# INNER WEST

## DEVELOPMENT ASSESSMENT REPORT

| <b>Application No.</b>                            | DA/2023/0099   |
| <b>Proposal</b>                                   | Partial demolition of existing structures and alterations and additions to the building to create a 3 storey shop top housing development comprising 2 commercial tenancies on the ground floor and 3 apartments above with associated car parking |

Figure 8: Breach with prescribed rear building envelope (blue dashed line)

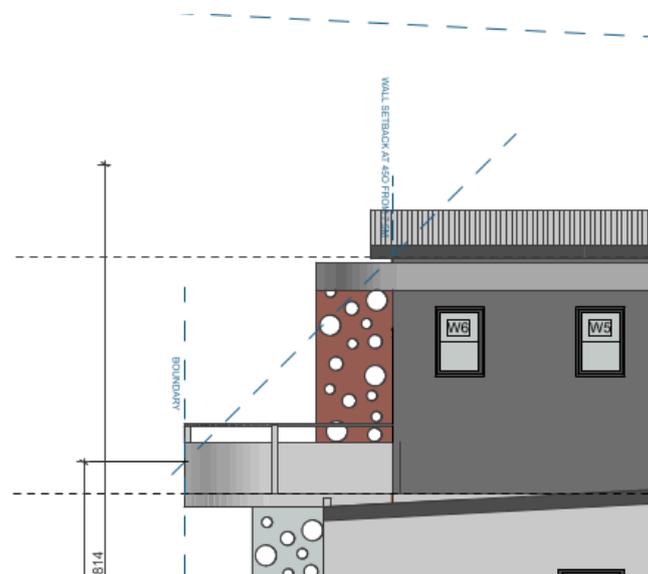
However, there is small portion of the building that extends beyond the prescribed building envelope (Figure 5). Notwithstanding this, these minor non-compliances are not considered to result in excessive visual bulk or amenity impacts on neighbouring properties to the rear, noting that the proposal complies with overshadowing controls and the development will not result in undue visual privacy impacts. The additional visual bulk, compared to a compliant envelope is minor, and not discernible from properties to the rear (along Dickson Street).

The rear building envelope is considered to contribute positively to the visual amenity of the laneway and provides laneway activation by providing appropriate lighting and opportunities for passive surveillance (i.e., balconies to the rear). As such, the proposal complies with control C13(iii).
